Illustrated Parts List - IPL Update

H550XP/XPG

1. Filter holder

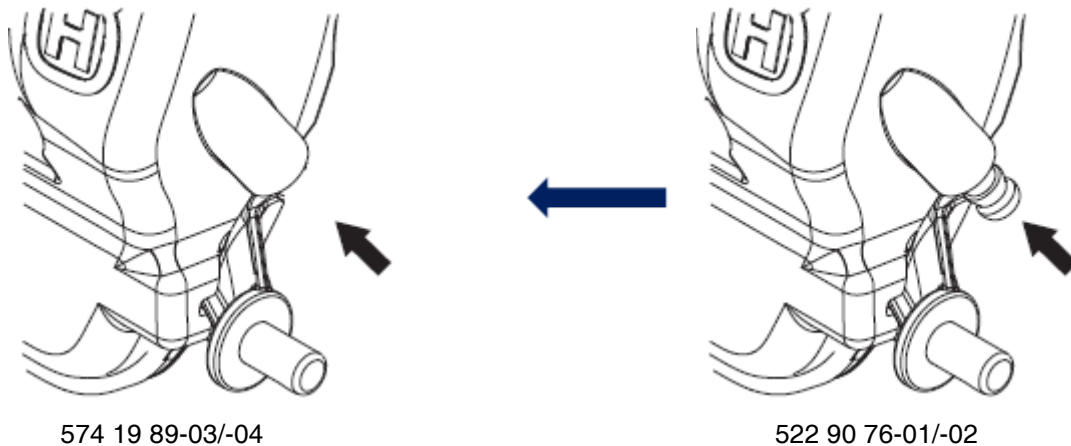
1. A new Filter holder,assy: 574 19 89-03 (standard) has been introduced. No nipple, hole removed to improve the startability.
The same change has been made on Filter holder,assy: 574 19 89-04 (heat).
2. A new Hose kit 589 35 71-01 replace the Hose 587 64 54-02. The new kit can be used for both new and old models regardless of which generation of filter holder the user have.
3. A new Hose 587 64 54-04 added for the new filter holders without nipple.
4. A new Inlet pipe, assy 525 50 00-03 has been introduced. The change has been made to ensure the assembly and to avoid leakage.
